Access Compliance Report

Public Rights-of-Way

(Pedestrian Signals)

Intersection ID: N/A	Main Street:	Cross Street: N/A	Location: N/A
ADA ID: 16B79BAF8DE7	Signal Type: Two Push Buttons-Non APS	Overall Compliance: No	Severity Score: BTN 1:N/A BTN 2: N/A No BTN: N/A
Codes/Mitigation Info/Possible Solution		Field Measurements/Component Compliance

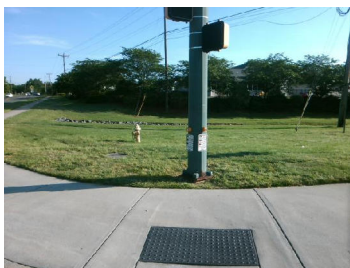
Surveyor Notes: TEXT HT 3/8

PROW/ADA: R410.6, TMUTCD 4e.08, R404.1, R406.2, R404.7.3

Yes	B 1 Clear Xing Direction?	ClearlyMarked	Yes	B 2 Clear Xing Direction?	ClearlyMarked
	B 1 Crossing Direction	To SW		B 2 Crossing Direction	To SE
Yes	B 1 DistanceTo XWalk (in)	24.0	Yes	B 2 DistanceTo XWalk (in)	16.0
No	B 1 DistanceTo Curb (in)	112.0	No	B 2 DistanceTo Curb (in)	112.0
Yes	B 1 Diameter (in)	2.0	Yes	B 2 Diameter (in)	2.0

Possible Solutions: Replace Signal Push Button With APS Button on New Post. Remove & Replace Sign.
